SERVICE BULLETIN

ENGINE - HP TURBINE ROTOR AND STATOR ASSEMBLY - PROVIDE NEW HPT BAND SEGMENT ASSEMBLIES
AND NEW HPT DUCT SUPPORT ASSEMBLIES - CATEGORY CODE 8 - MOD.ENG-72-0124

V2500-ENG-72-0124

Location of Stage 2 HPT Duct Support Assembly
Fig.1

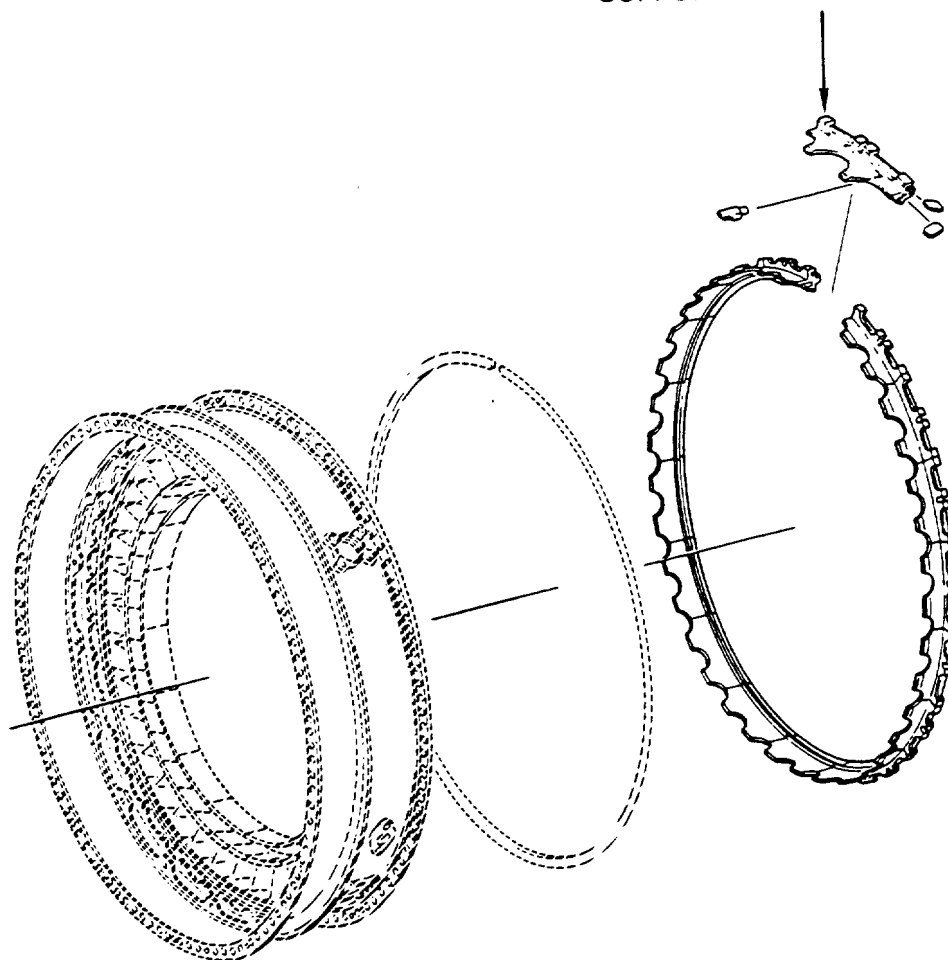
REPLACE THE 2A0189
STAGE 2 HPT DUCT SUPPORT
ASSEMBLIES WITH THE 2A2270
STAGE 2 HPT DUCT
SUPPORT ASSEMBLIES (19 off)

- (1) Install the 2A2270 Stage 2 HPT Duct Support Assembly (19 off) by the procedure given in Reference (4), Chapter/Section 72-45-20, Assembly-01. Refer to Figure 1.
- (2) Install the 2A2269-01 Stage 2 HPT Band Segment Assemblies (1 off) and the 2A2271-01 Stage 2 HPT Band Segment Assemblies (2 off). Use the procedure given in Reference (4), Chapter/Section 72-45-20, Assembly-01. Refer to Figure 2.

Location of Stage 2 HPT Band Segment Assembly
Fig.2

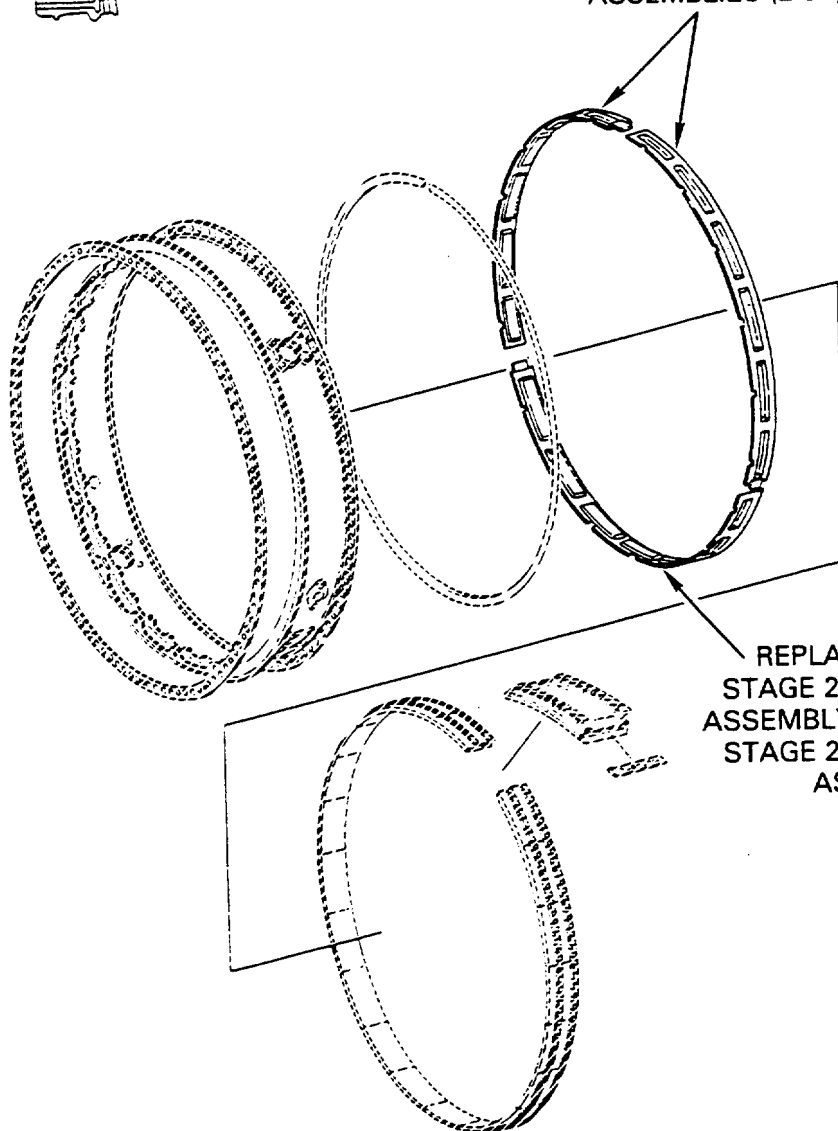
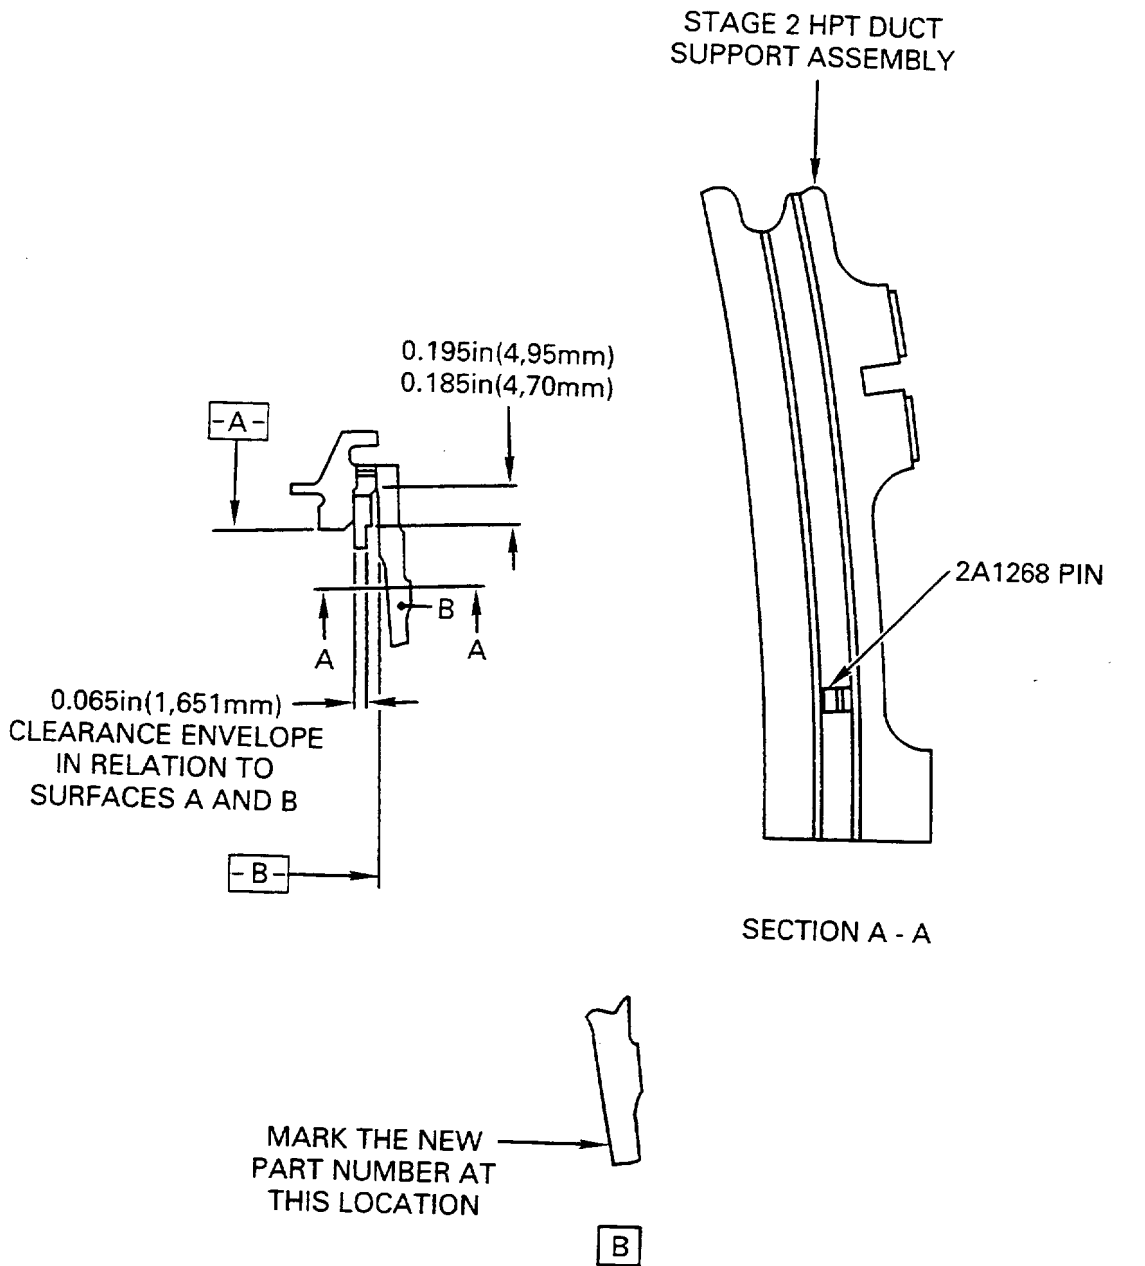
REPLACE THE 2A0195 - 01
STAGE 2 HPT BAND SEGMENT
ASSEMBLIES WITH THE 2A2271 - 01
STAGE 2 HPT BAND SEGMENT
ASSEMBLIES (2 off)

REPLACE THE 2A0198 - 01
STAGE 2 HPT BAND SEGMENT
ASSEMBLY WITH THE 2A2269 - 01
STAGE 2 HPT BAND SEGMENT
ASSEMBLY (1 off)

Family tree - Stage 2 HPT Duct Support Assembly
Fig.4

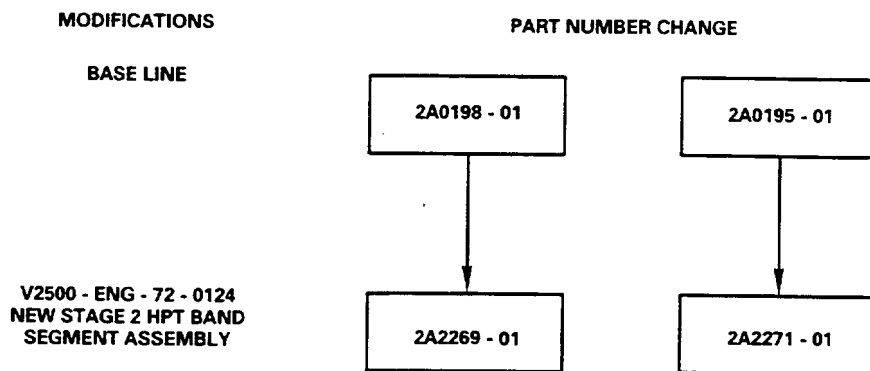
V2500 - ENG - 72 - 0124
NEW STAGE 2 HPT DUCT
SUPPORT ASSEMBLY

PART NUMBER CHANGE
